### **ZONING CHANGE REVIEW SHEET**

**CASE:** C14-2016-0069 / Ben White Zoning **P.C. DATE:** September 27, 2016

ADDRESS: 5016 1/2 E Ben White Boulevard WB AREA: 12.82 acres

### SP 3) Compatibility Standards

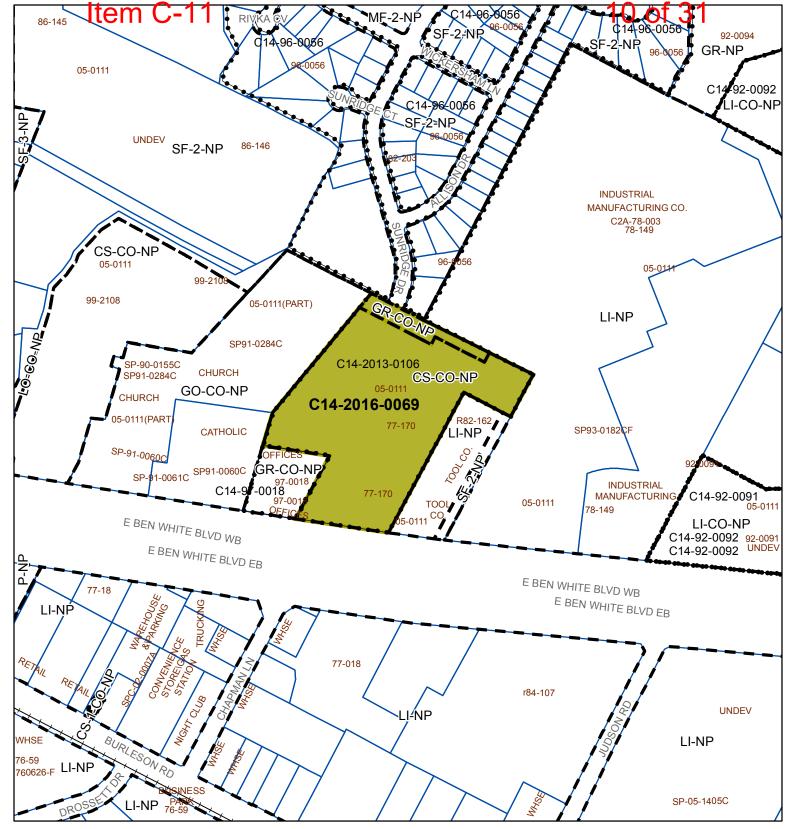
The site is subject to compatibility standards. Along the North SF-2 triggering property line, the following standards apply:

- No structure may be built within 25 feet of the property line. Or triggering Property line
- No structure in excess of two stories or 30 feet in height may be constructed within 50 feet of the triggering property line.

- No structure in excess of three stories or 40 feet in height may be constructed within 100 feet of the triggering property line.
- No parking or driveways are allowed within 25 feet of the property line.
